PETITION NO: SLUP-2

PROPOSED USE: Expansion Of Tank
Farm Facility

APPLICANT: Marathon Petroleum Company, LLC

PLANNING COMMENTS: Staff Member Responsible: John P. Pederson, AICP

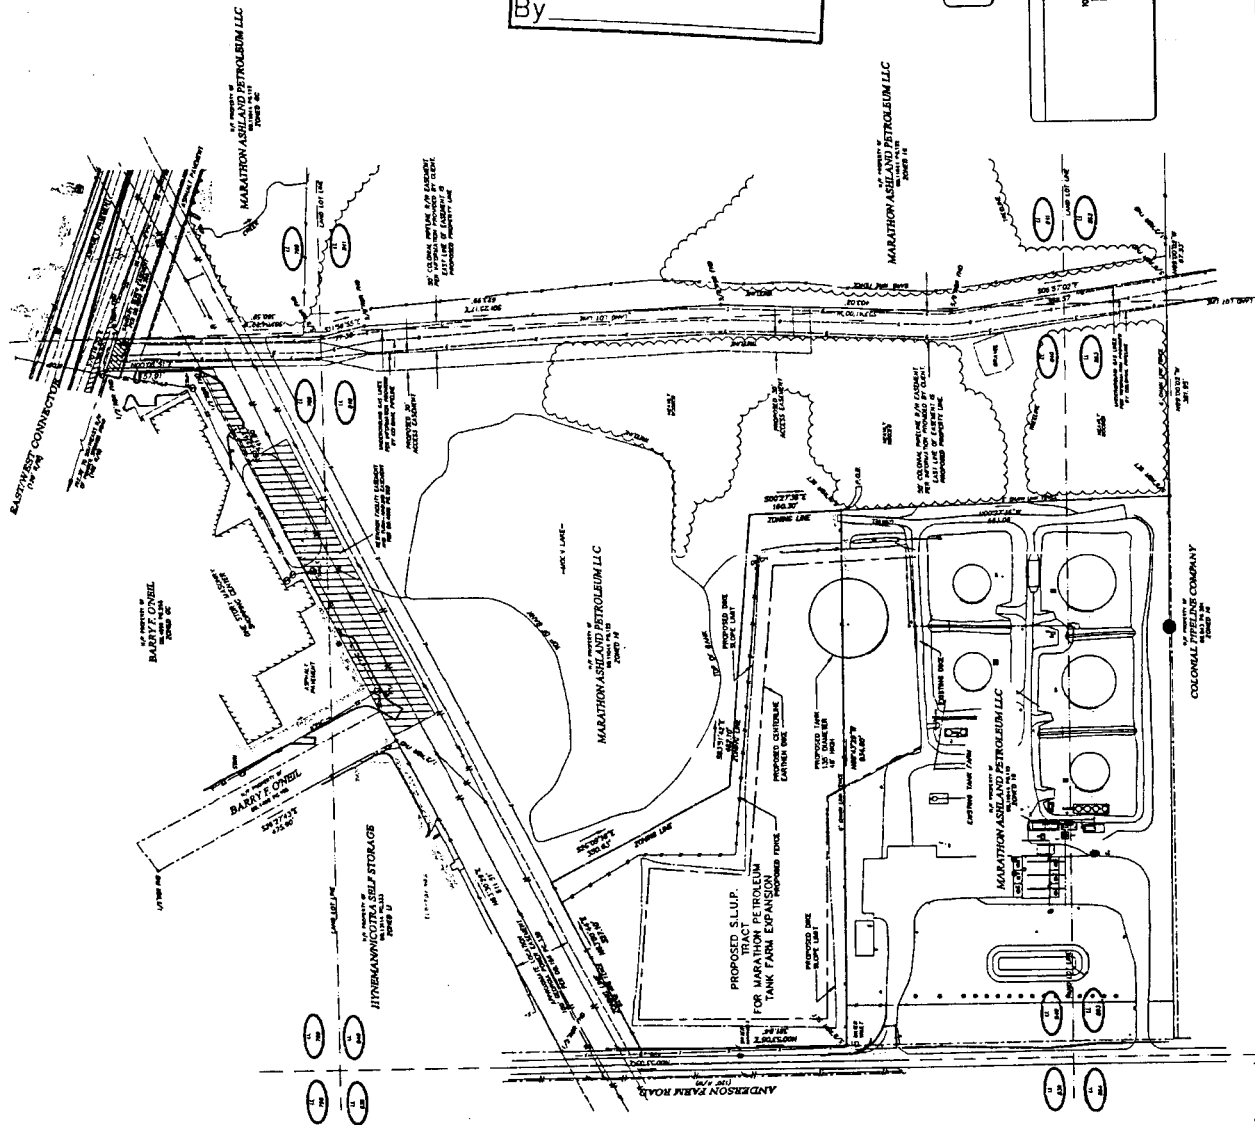
1. The proposed tank expansion is located within the existing Marathon Petroleum Company site. The new tank will be located within a spill containment dike. The applicant must provide the required spill prevention measures and spill prevention plan at Plan Review..

- Site plan received by the Zoning Division on January 4, 2007;
- Fire Department comments;
- Water and Sewer comments and recommendations;
- Stormwater Management comments and recommendations; and
- DOT comments and recommendations.
